Ventura County Community College District

DATE: May 15, 2025
TO: All Bidders
FROM: Spencer Herson, Purchasing Specialist
SUBJECT: Addendum 1 – Bid 709, Ventura College Stem Program Building Improvements

Drawings: Changes and clarifications noted as Addendum 01 and dated 05/15/25

SHEET NUMBER: C2.0

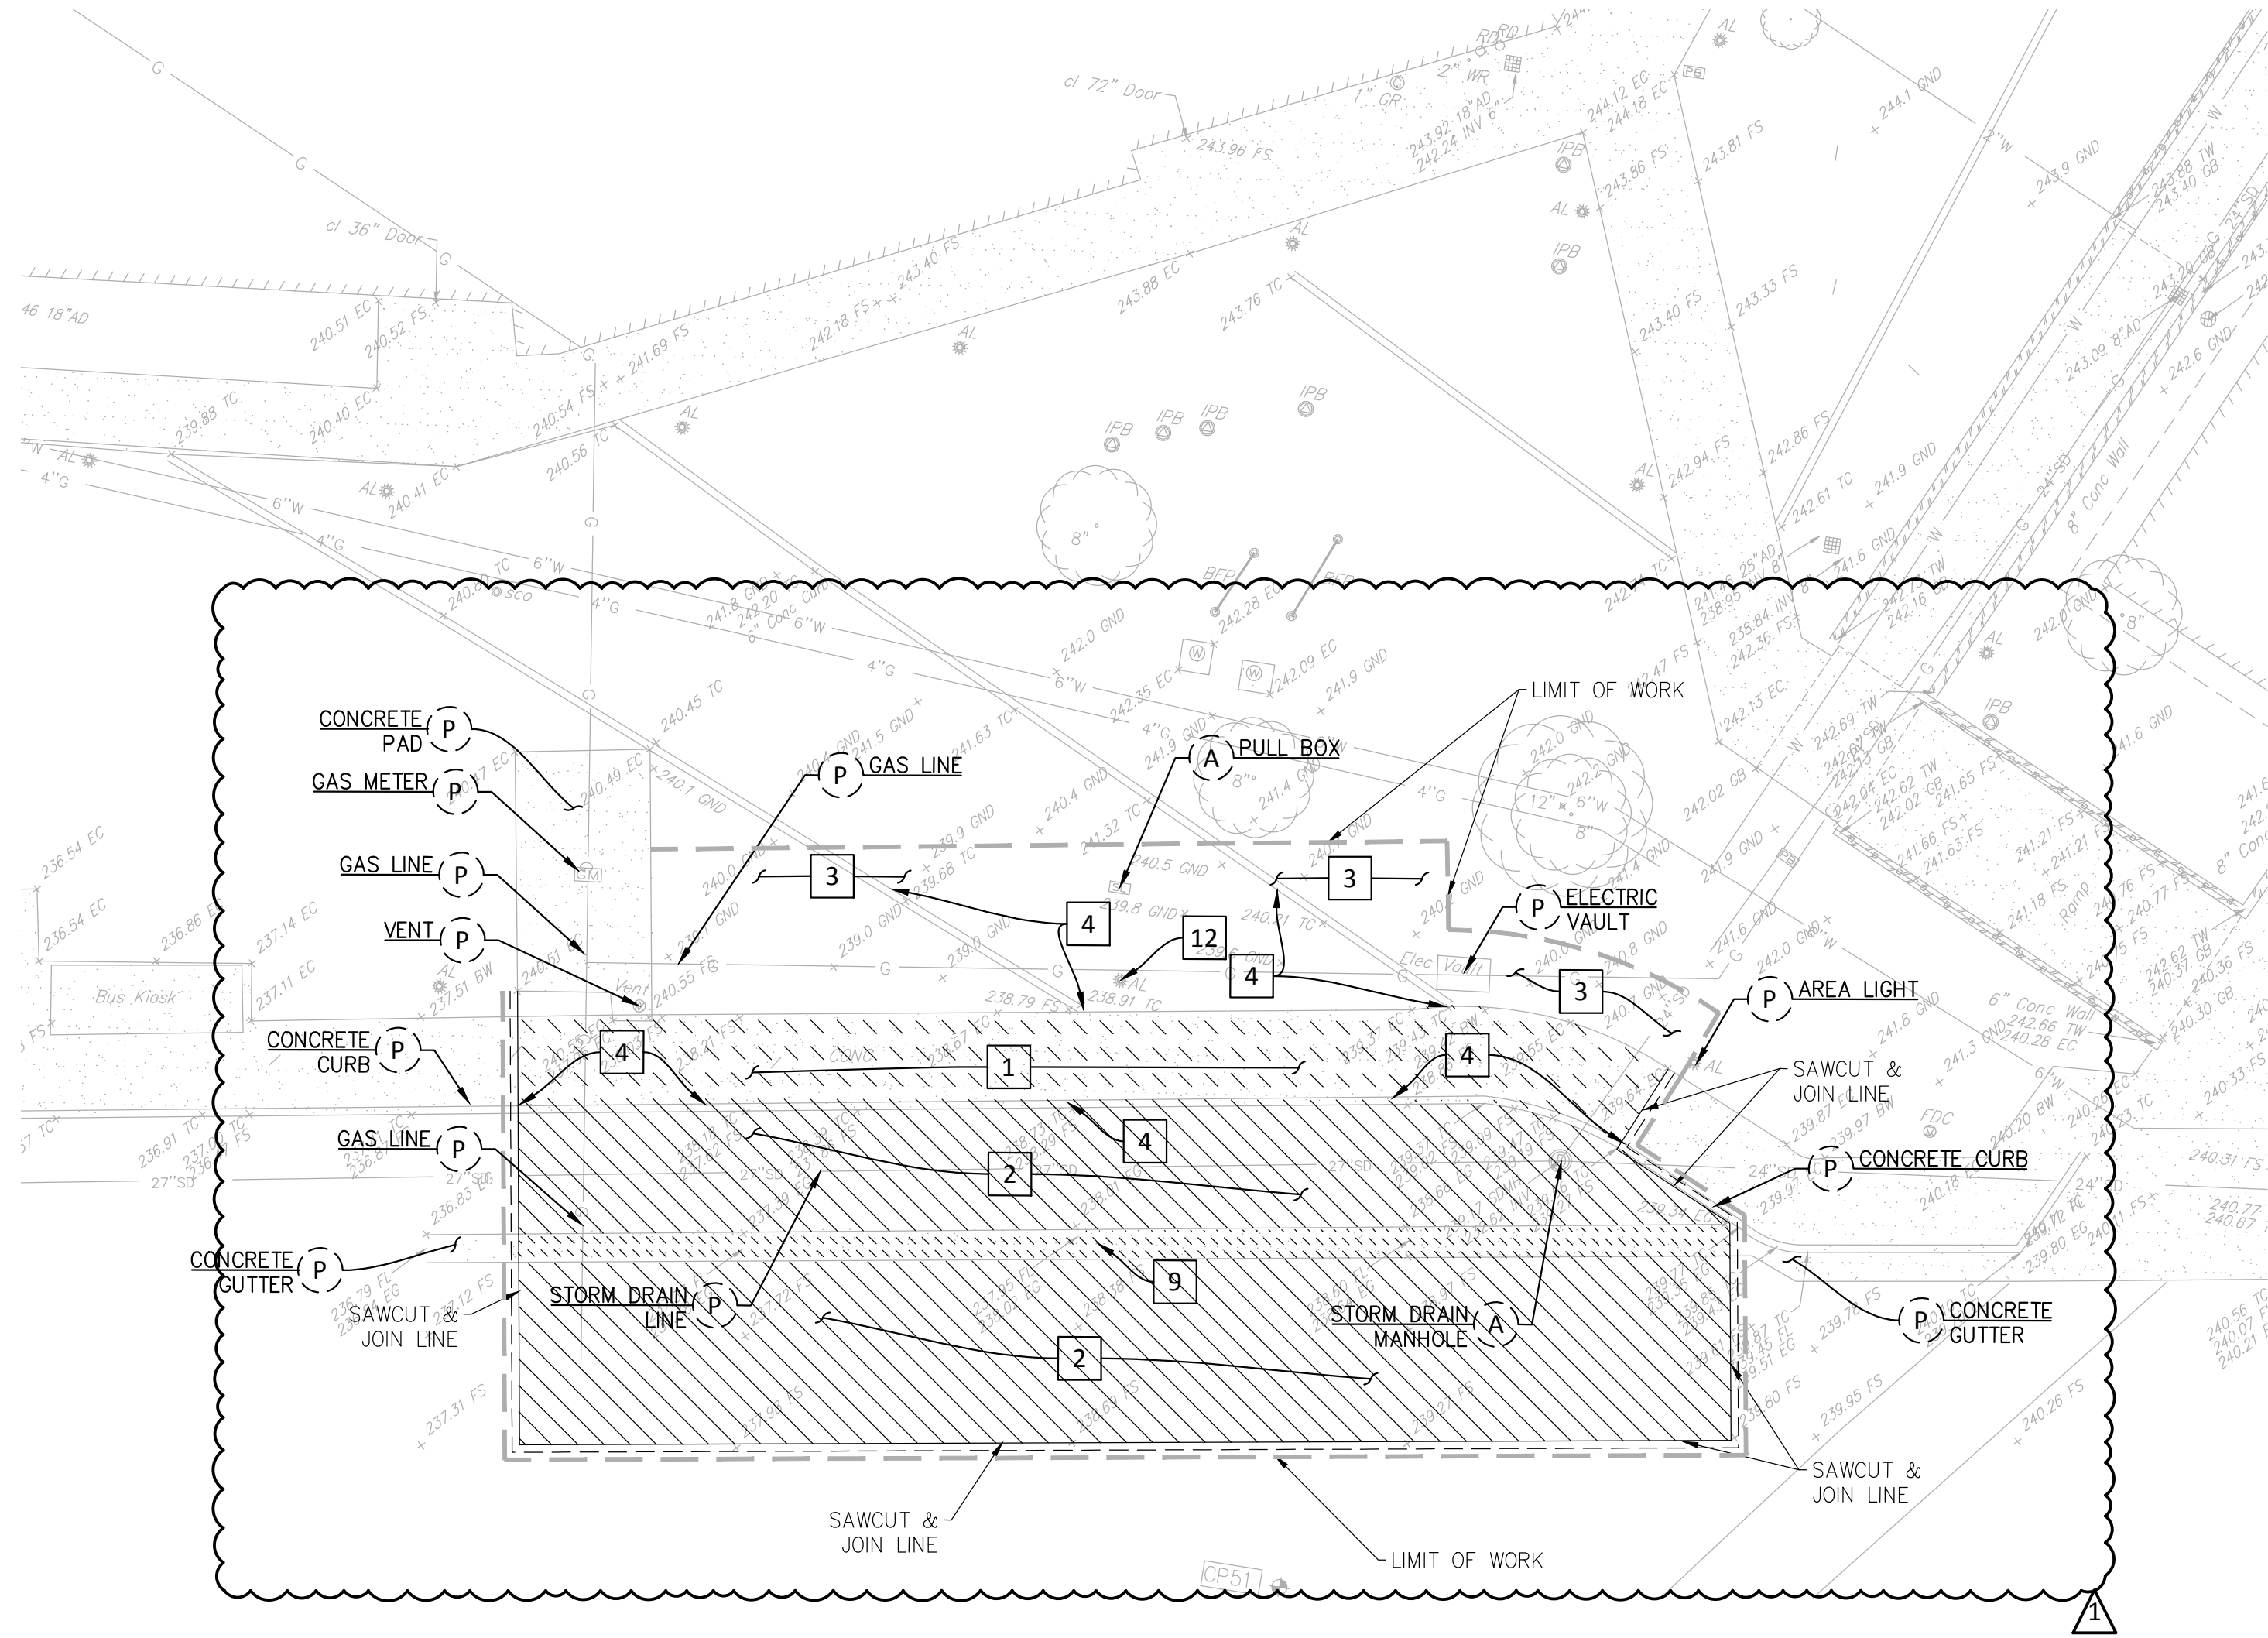
C2.0 – ADDED DEMOLITION FOR SEWER TRENCHING, ADDED EXISTING SEWER LINE WITH PROTECT IN PLACE NOTE, DEMOLITION NOTES 8, 9 AND 12

SHEET NUMBER: C2.1

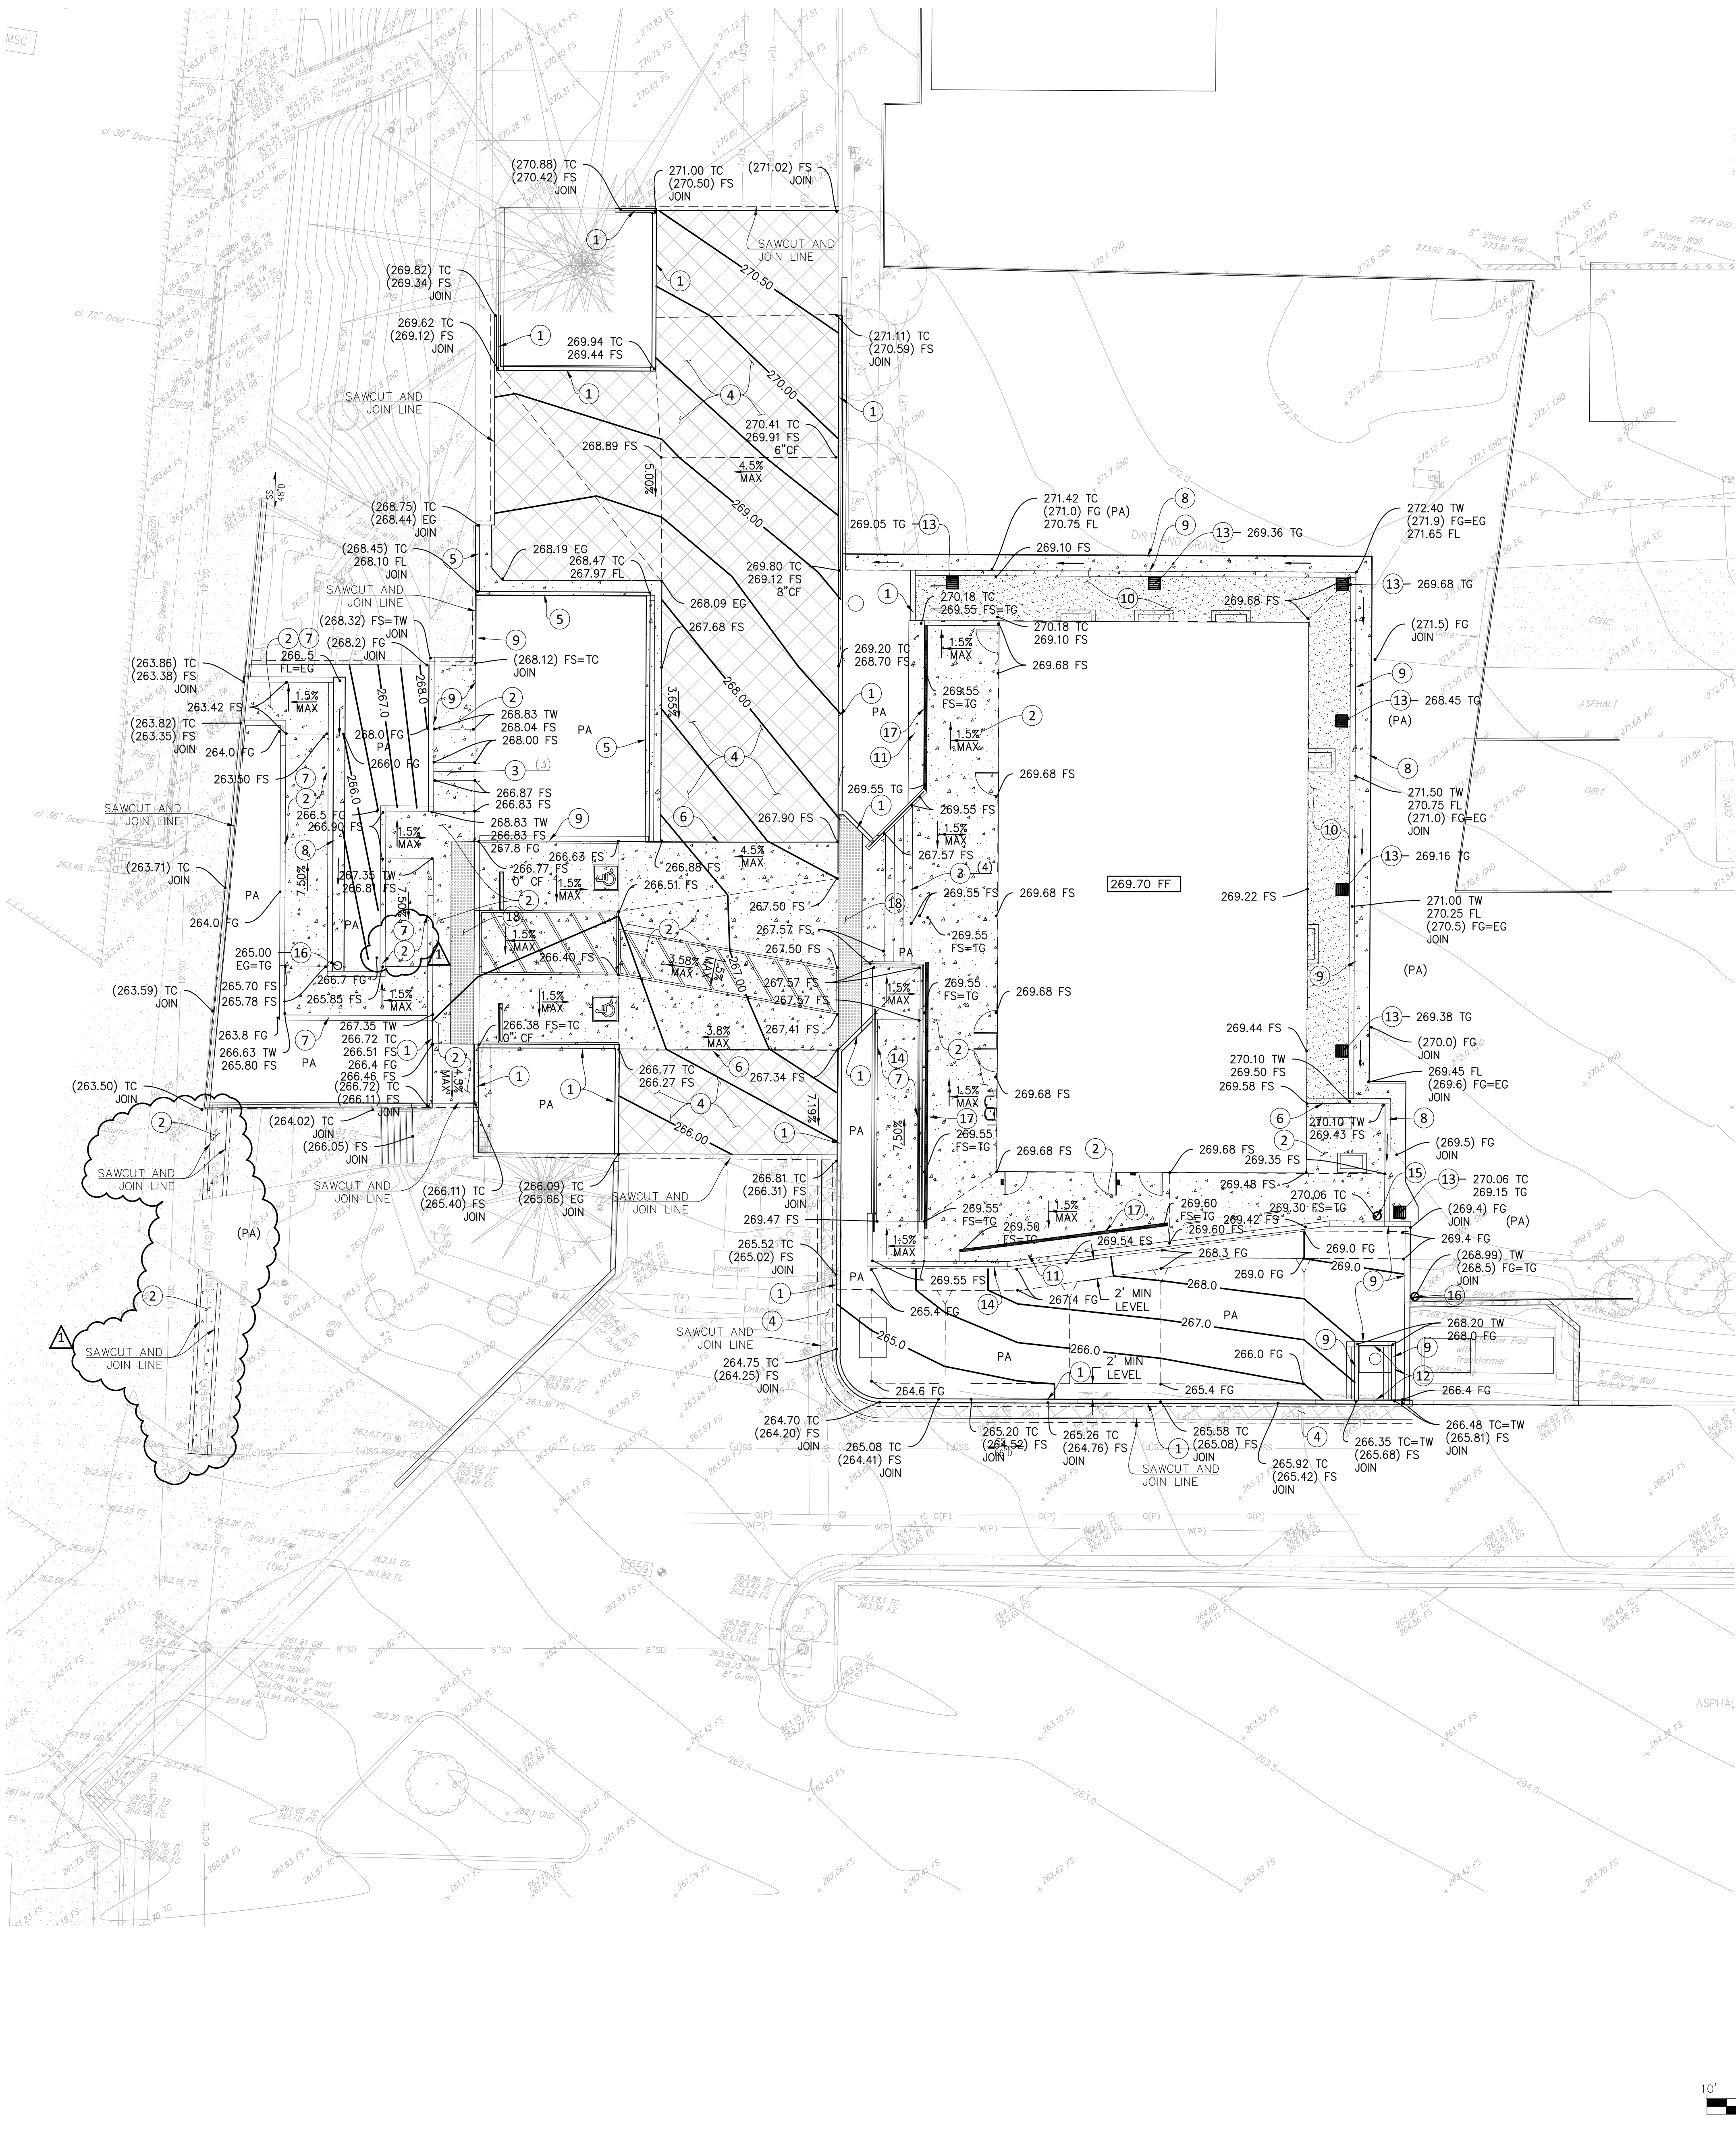
C2.1 – DEMOLITION PLAN FOR DROP-OFF AREA

GRADING PLAN

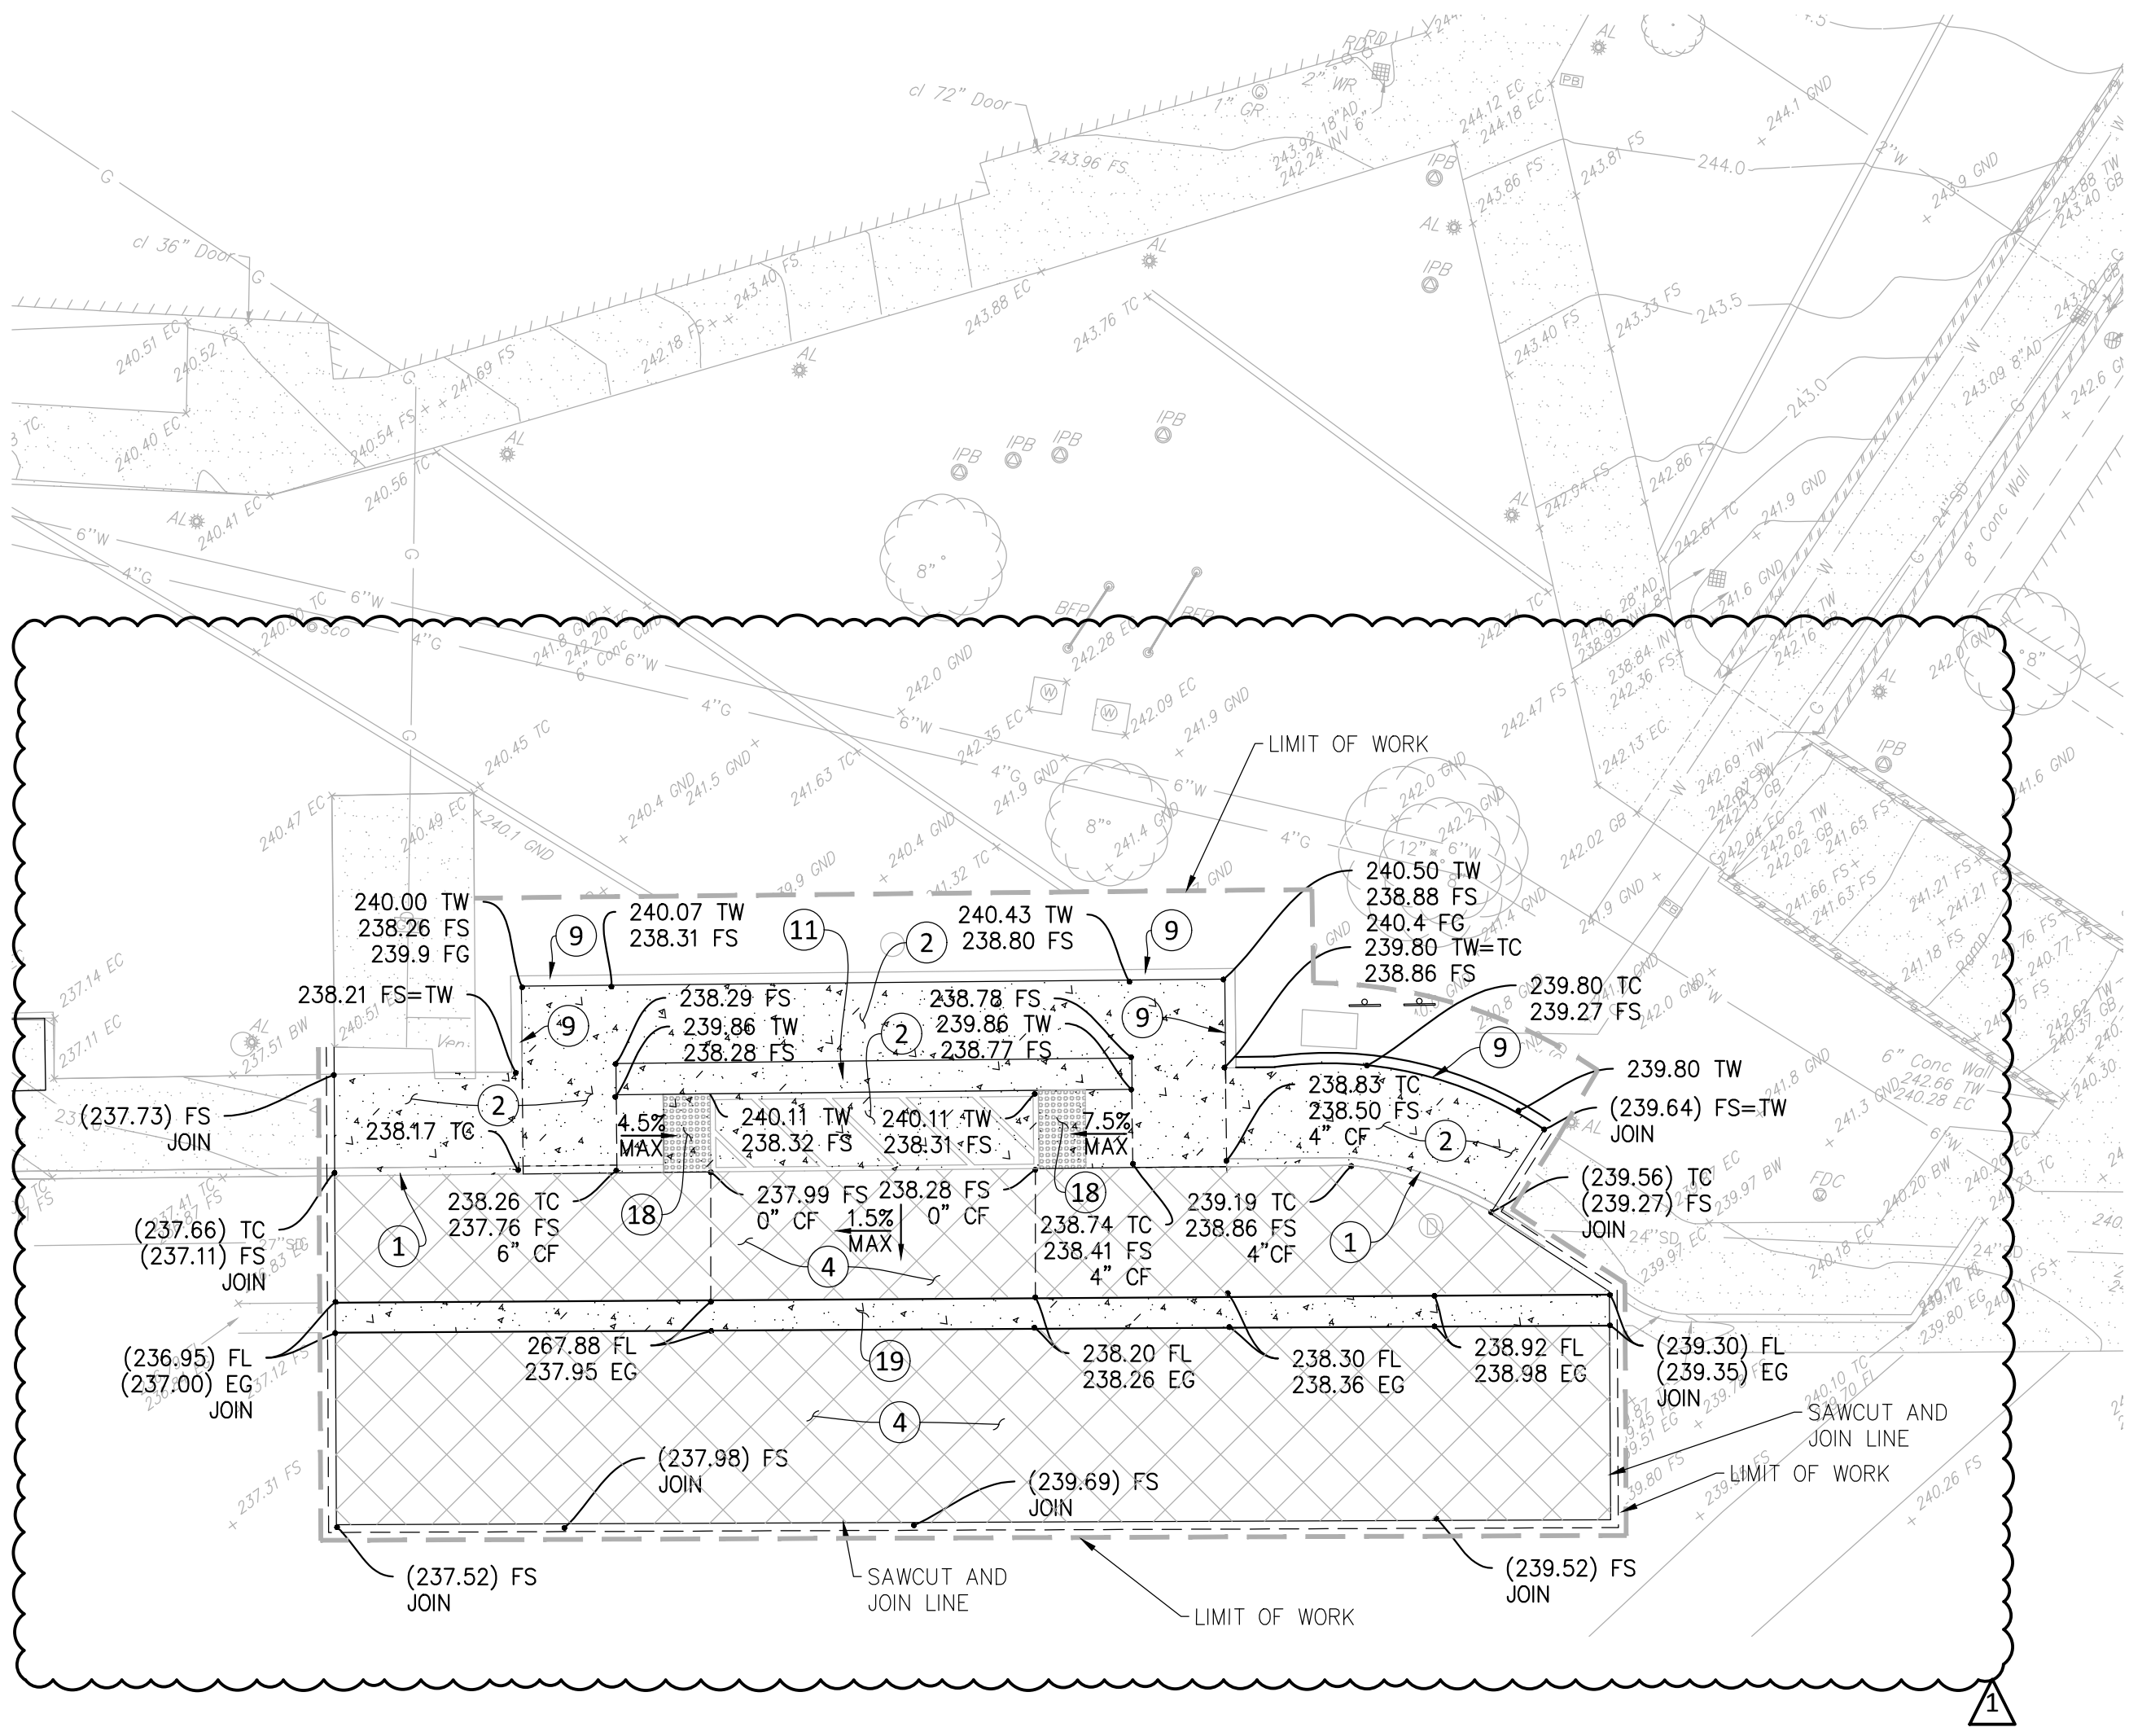
C3.0 – ADDED CONCRETE PAVEMENT NOTE FOR NEW SEWER LINE TRENCHING, REVISED CONSTRUCTION KEYNOTE 1, ADDED GENERAL NOTE 6, ADDED KEYNOTE 9
